ADDENDUM

NO. 3

PROJECT NAME: Hays High School 2025 Additions and Renovations

ADDENDUM DATE: 15 May, 2025

FOUNDATION PLAN -
SAWJOINTS - AREA B

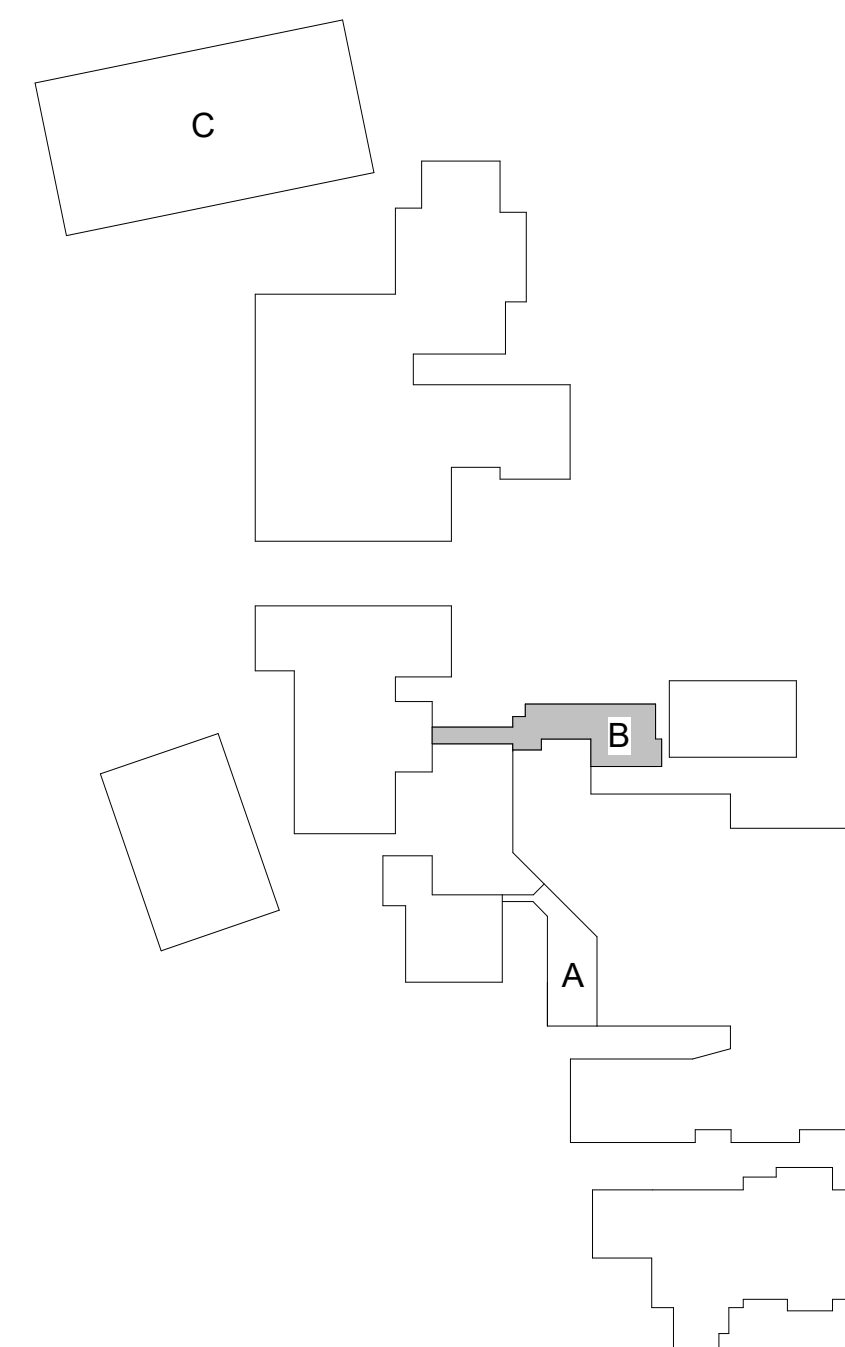
AD No 3, Struct Item 4: **To the Drawings, Sheet S2.1B1S, "FOUNDATION PLAN - SAWJOITS - AREA B,"**

- 1) Revised sawjoint layout in area B slab on grade.

1 SECOND LEVEL FRAMING PLAN - AREA B

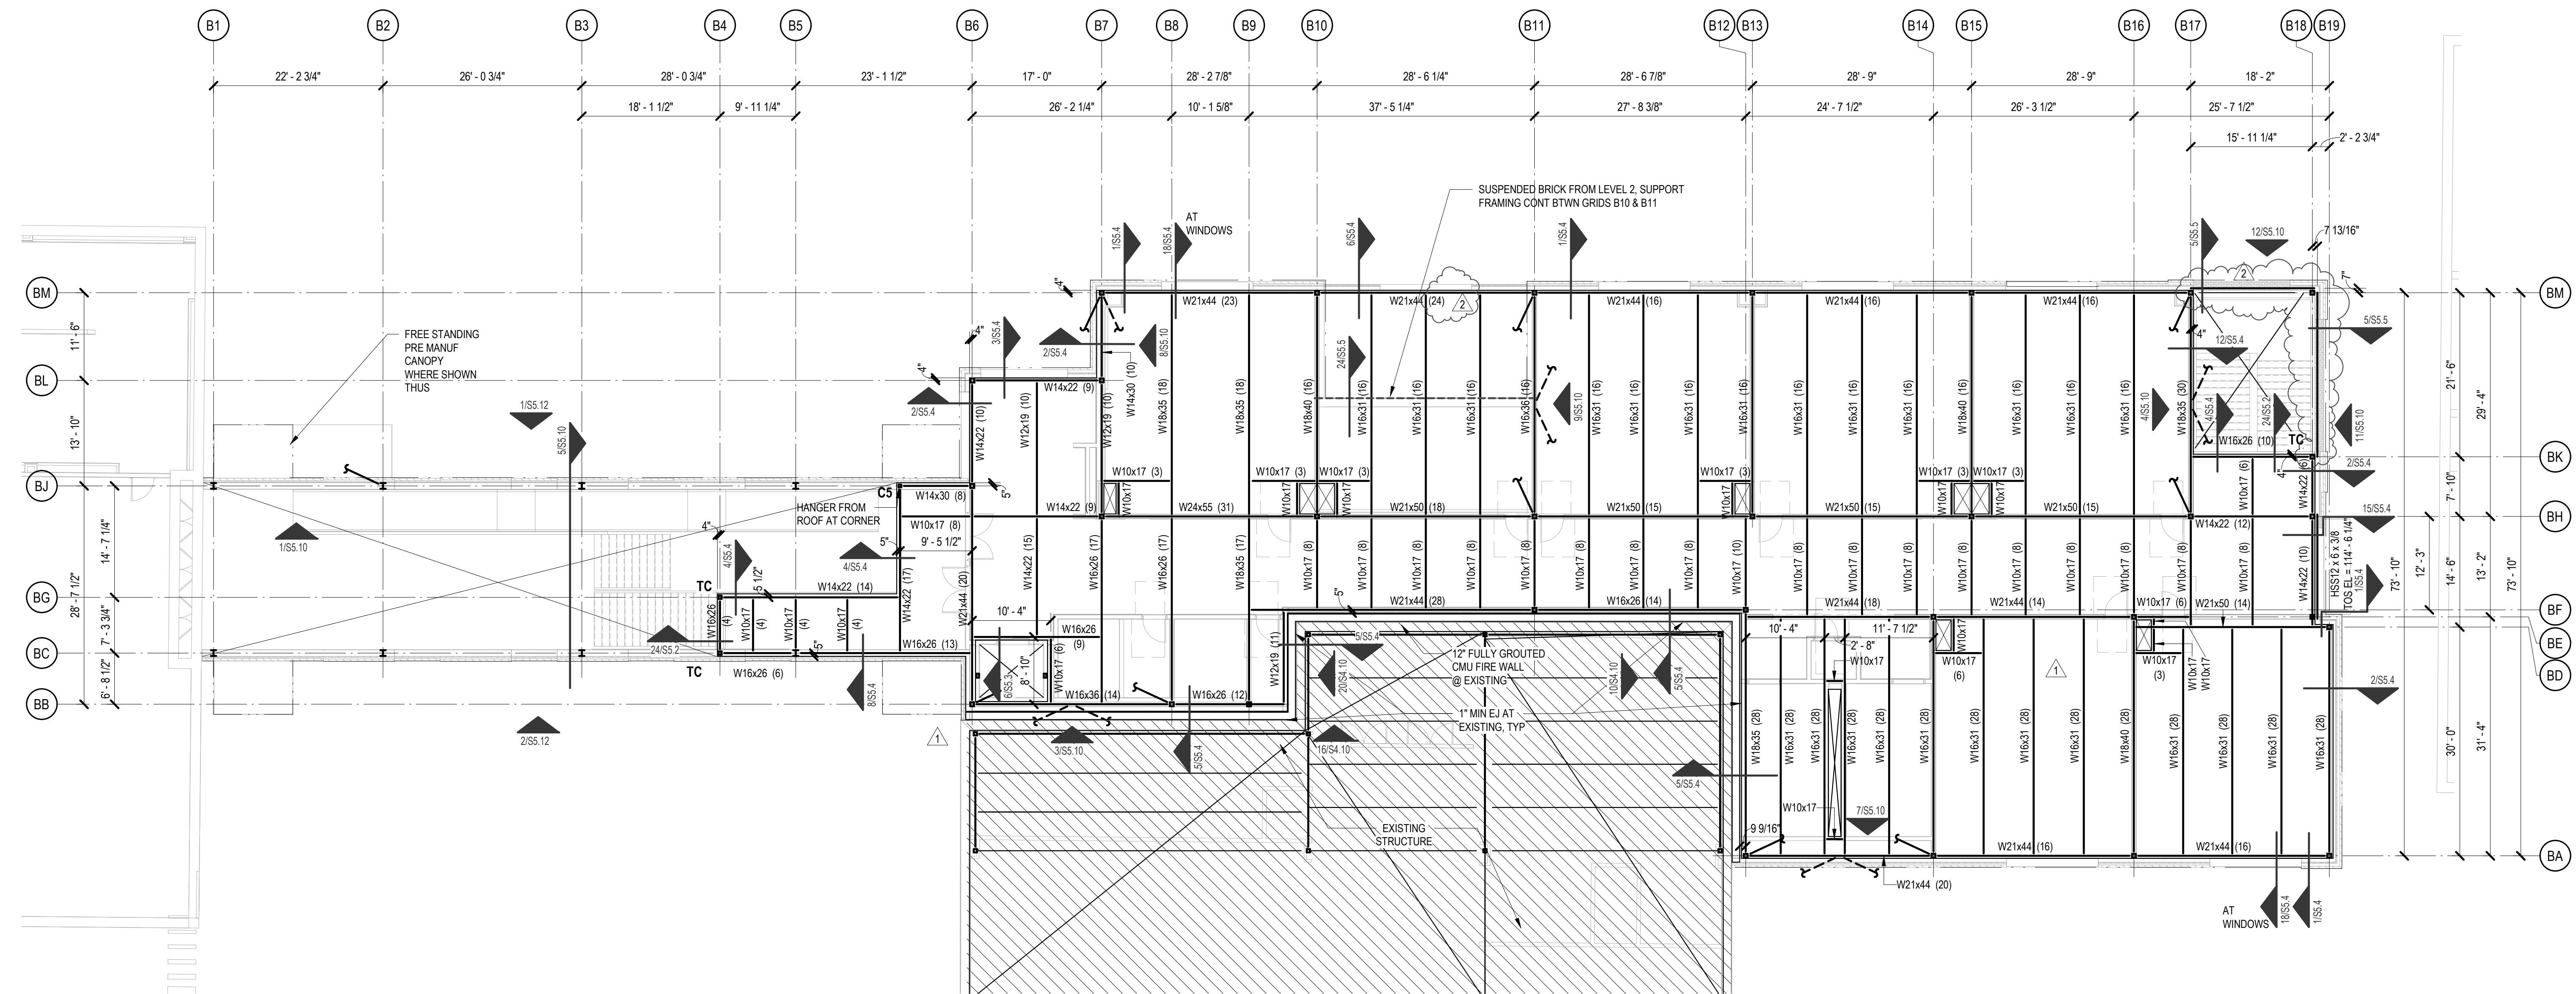
AD No 3, Struct Item 5: **To the Drawings, Sheet S2.1B2, "LEVEL 2 FRAMING PLAN - AREA B,"**

- 1) Removed duplicate beam sizes where shown
- 2) Revised stud count where shown

11 FRAME ELEVATION GRID 18
3/16" = 1'-0"

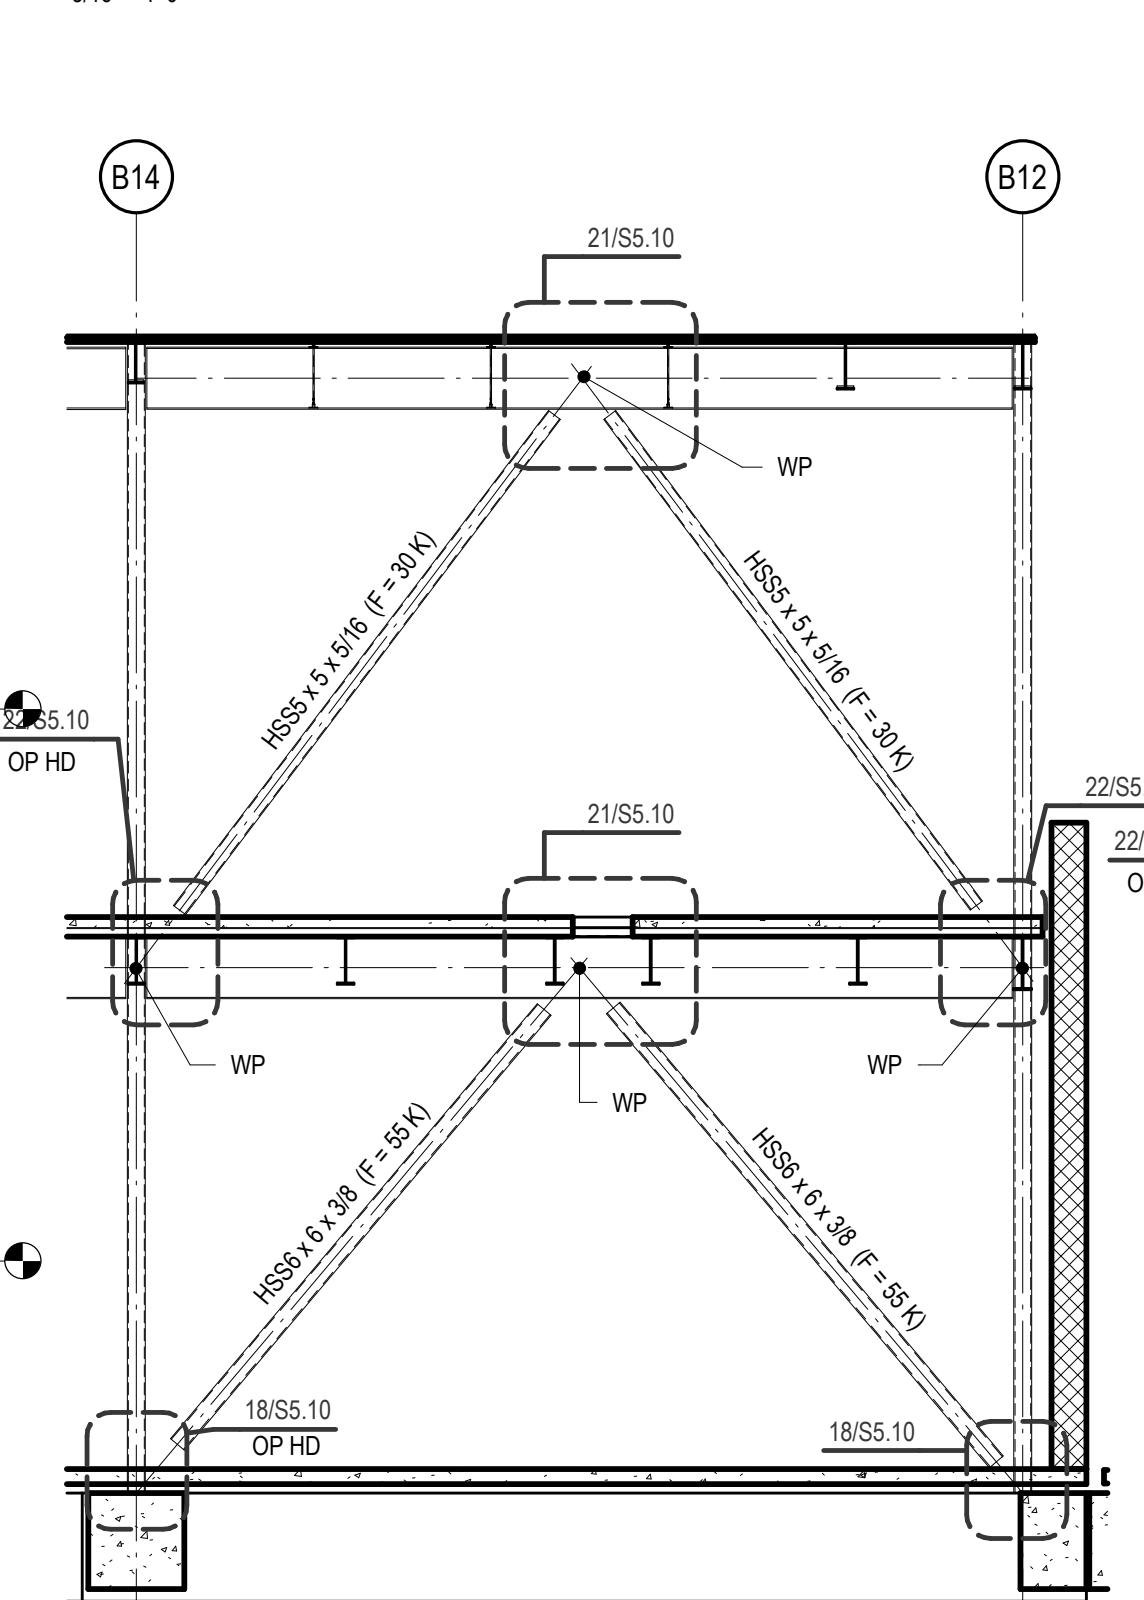
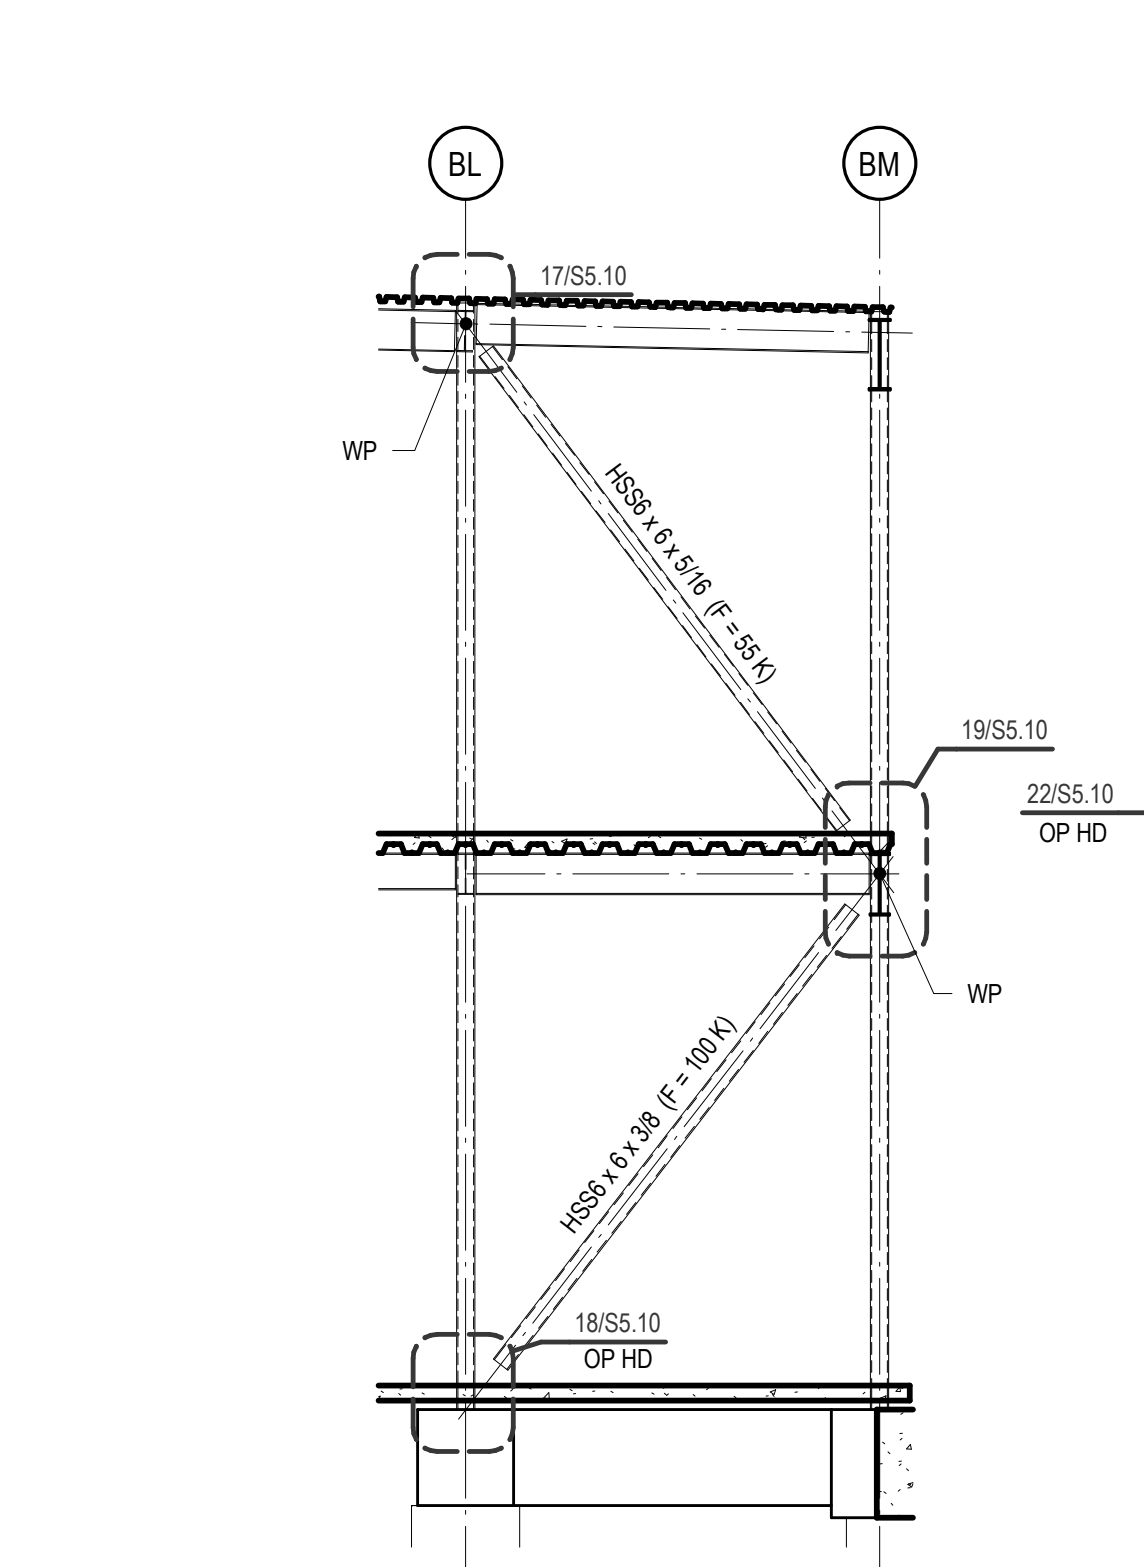
AD No 3, Struct Item 14: **To the Drawings, Sheet S5.10, "BRACE ELEVATIONS AND DETAILS,"**

- 1) Elevation 3 – Fixed graphics.
- 2) Elevation 11 & 12 – Revised beam size

1 FLOOR PLAN - AREA A - KITCHEN

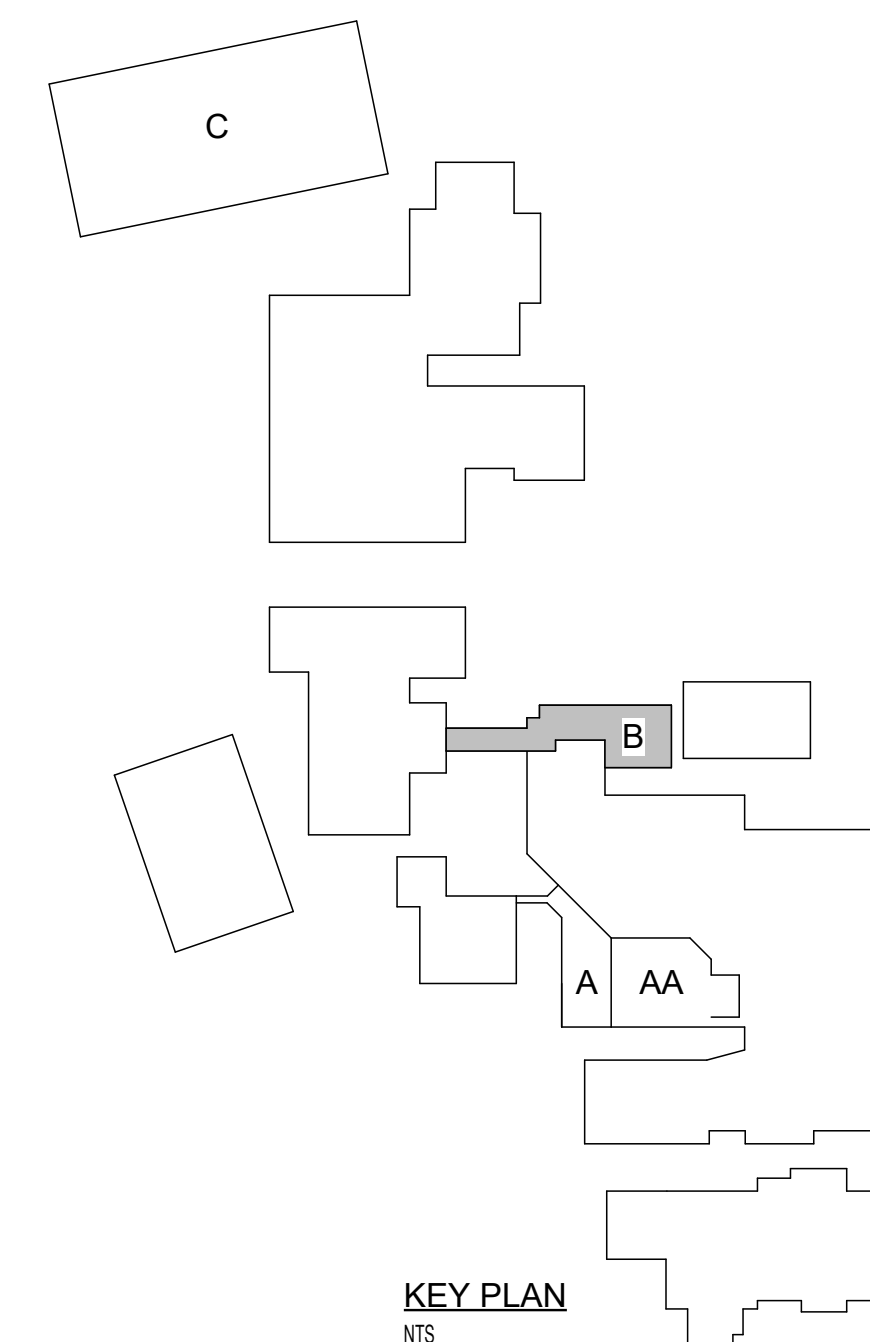
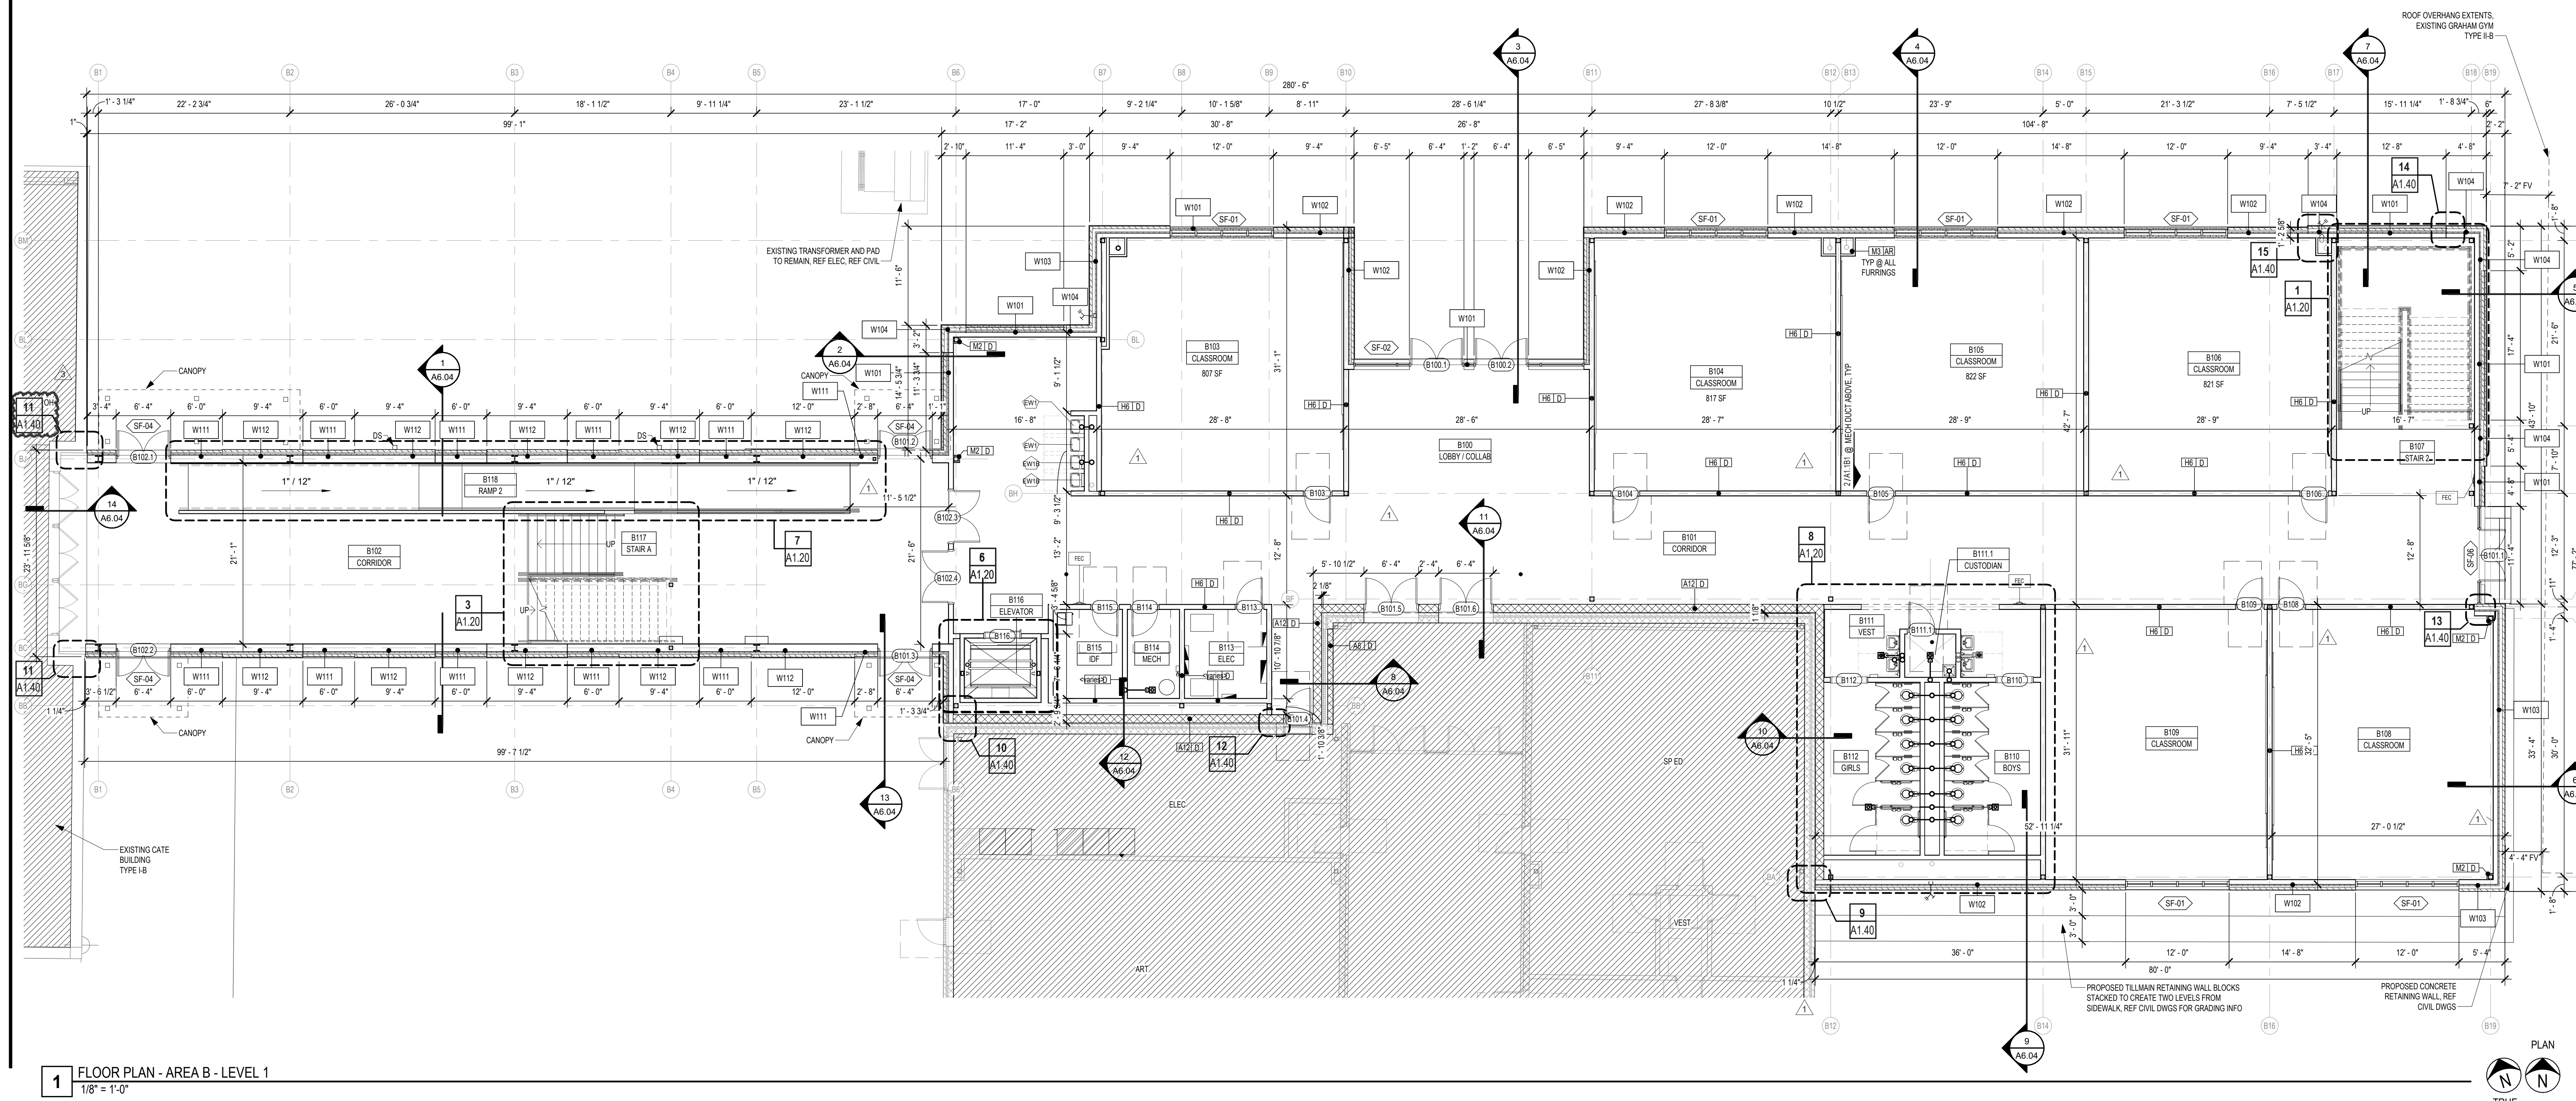
AD No 3, Arch Item 4: To the Drawings, Sheet A1.1A1, "FLOOR PLAN – AREA 1 – KITCHEN,"

- 1) Updated wall types W105A and W106A to clarify stud size and wall type
- 2) Removed canopy manufacturer's name from floor plan
